## Technical Service Bulletin

Transaction No.: **2082553/2**

90 Panoramic display: noises in area of panoramic display, noises between panoramic display and background light module

**Figure 1.** Attaching a piece of felt (example image).

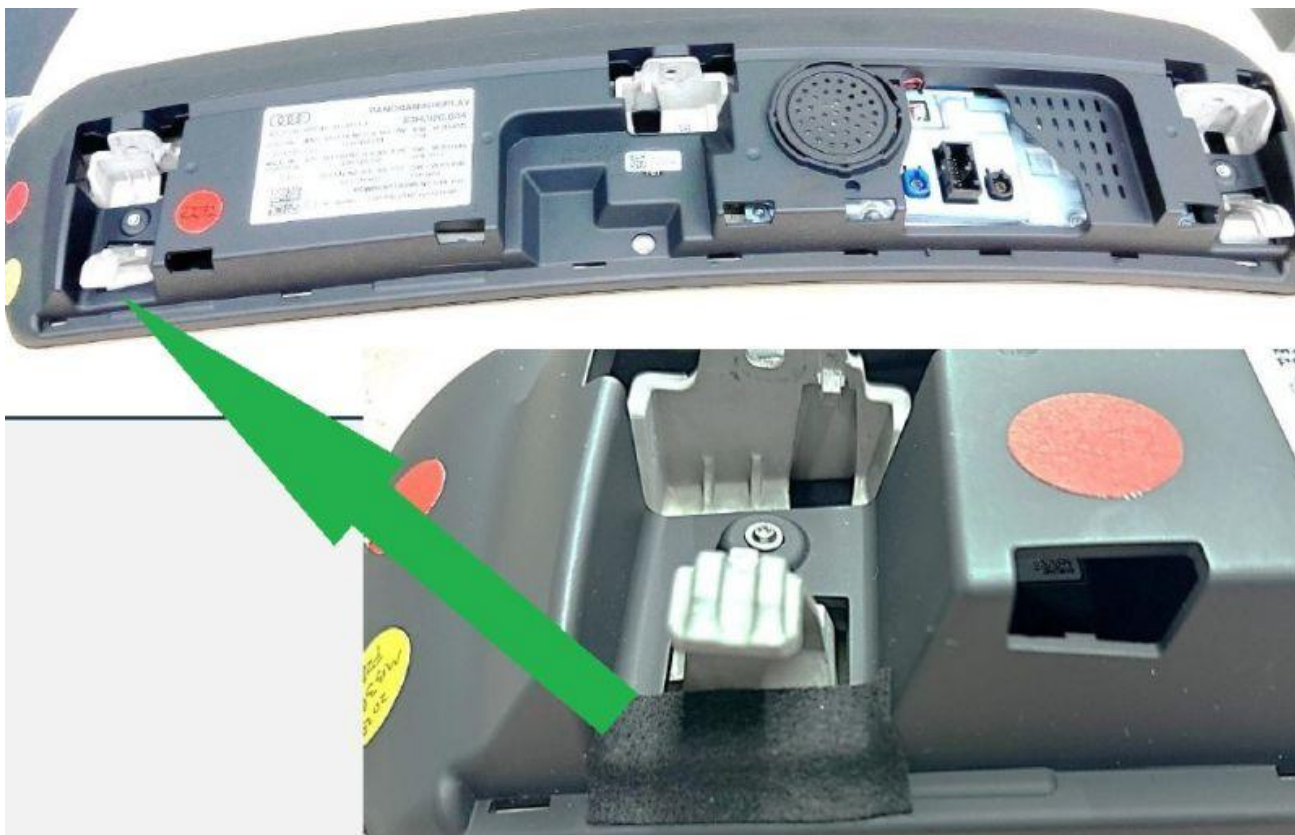
Noises can be traced to the area between the panoramic display and the background lighting module under the panoramic display.

Noises between panoramic display and background lighting module on vehicles fitted with the optional **background lighting package**.

Please attach a piece of **felt (part number 443 857 991 Q)** in the area indicated by a green arrow in the image.
